Access Compliance Report Public Rights-of-Way (Curb Ramps)

Main Street: CRESTMONT_CT Cross Street: LEWISTON_CT Location: NW

ADA ID: RPRK211104141122 Ramp Type: Type 4 - Parallel Initial Pass/Fail: Fail Overall Compliance: No Severity Score: 15

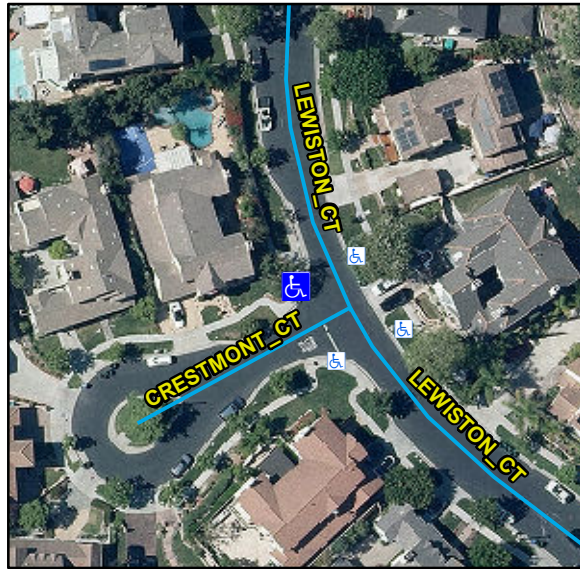
Compliance	Description	Data	Compliance	Description	Data
N/A	Ramp Length LT (in)	115	N/A	Ramp Length RT (in)	118
Yes	Ramp Width LT (in)	54	Yes	Ramp Width RT (in)	54
Yes	Ramp Run Slope LT (%)	1.1	No	Ramp Run Slope RT (%)	9.4
Yes	Ramp Cross Slope LT (%)	0.8	Yes	Ramp Cross Slope RT (%)	0.5
N/A	Landing Present	N/A	N/A	DWS Provided	N/A
N/A	Landing Length (in)	N/A	N/A	DWS Contrast	N/A
N/A	Landing Width (in)	N/A	N/A	DWS Length (in)	N/A
N/A	Landing Run Slope (%)	N/A	N/A	DWS Full Width	N/A
N/A	Landing Cross Slope (%)	N/A		DWS Offset Type	N/A
N/A	Landing Movement Obstructed?	N/A	N/A	DWS Offset Left (in)	N/A
	Landing Movement Type	N/A	N/A	DWS Offset Right (in)	N/A
N/A	Landing Shared	N/A			
N/A	Clear Space	Yes			
N/A	Clear Space To Crosswalk (in)	N/A			
N/A	Marked Crosswalk 1	No	N/A	Marked Crosswalk 2	No
	Crossing 1 Direction	S		Crossing 2 Direction	E
	Marked Crosswalk 1 Width (in)	N/A		Marked Crosswalk 2 Width (in)	N/A

Remove & Replace Curb Ramp With Two New Directional Ramps or Equivalent.
